Submit 1 Copy To Appropriate District	State of New Mexico Energy, Minerals and Natural Resources OIL CONSERVATION DIVISION 1220 South St. Francis Dr.		Form C-103
<u>District I</u> – (575) 393-6161 1625 N. French Dr., Hobbs, NM 88240			Revised July 18, 2013 WELL API NO.
<u>District II</u> – (575) 748-1283			30-015-20051
811 S. First St., Artesia, NM 88210 <u>District III</u> – (505) 334-6178			5. Indicate Type of Lease
1000 Rio Brazos Rd., Aztec, NM 87410	Santa Fe, NM 87505		STATE FEE S
<u>District IV</u> – (505) 476-3460 1220 S. St. Francis Dr., Santa Fe, NM 87505	Santa i C, ivivi o	7303	6. State Oil & Gas Lease No.
SUNDRY NOTICES AND REPORTS ON WELLS (DO NOT USE THIS FORM FOR PROPOSALS TO DRILL OR TO DEEPEN OR PLUG BACK TO A DIFFERENT RESERVOIR. USE "APPLICATION FOR PERMIT" (FORM C-101) FOR SUCH			7. Lease Name or Unit Agreement Name Jackson AT
PROPOSALS.)			8. Well Number

13. Describe proposed or completed operations. (Clearly state all pertinent details, and give pertinent dates, including estimated date of starting any proposed work). SEE RULE 19.15.7.14 NMAC. For Multiple Completions: Attach wellbore diagram of			
proposed completion or recompletion.			
EOG Y Resources, Inc.

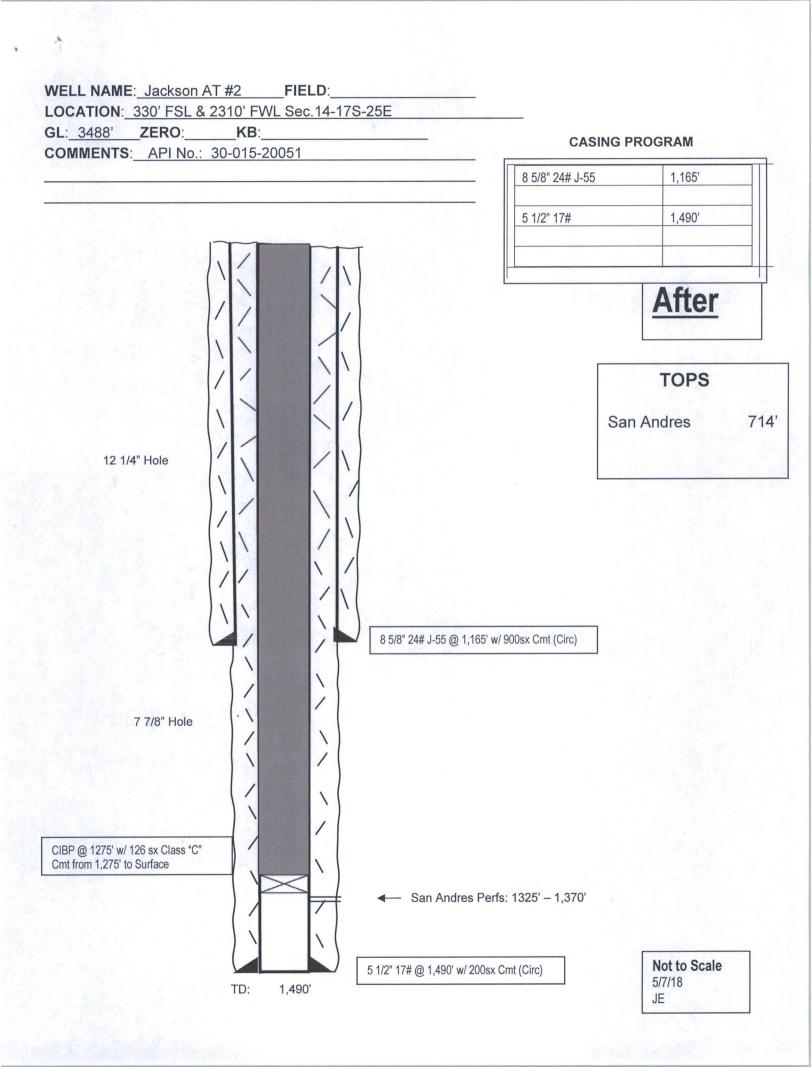
1. MIRU all safety equipment as needed. TOH with production equipment.			
2. RIH with GR/JB to 1300'. 3. Set a CIBP at 1275'			
4. Load the hole with fresh water, pressure test casing to 500 psi and effeulate a 126 sx Class "C" cement plug from 1275' up to surface. WOC. Parf @ 500' + Attempt to 500 to 500 psi and effeulate a 126 sx Class "C" cement plug from 1275' up to surface.

5. Back fill as needed. 6. Cut off wellhead, install dry hole marker and clean location. 85/8 Not Circ. to Sort. 			
Wellbore schematics attached			
			MAY 1 4 2018
			POSTOCK APTERIA O C P
Spud Date:	Rig Release Da	nte:	DISTRICT II-ARTESIA O.C.D.

* See Attached COA's Must be Plugged by 5-15-19			
I hereby certify that the information above is true and complete to the best of my knowledge and belief.			
SIGNATURE TITLE Regulatory Specialist DATE May 9, 2018			
Type or print name Tina Huerta E-mail address: tina huerta@eogresources.com PHONE: 575-748-4168 For State Use Only			
APPROVED BY: DATE 5-15-18 Conditions of Approval (if any):
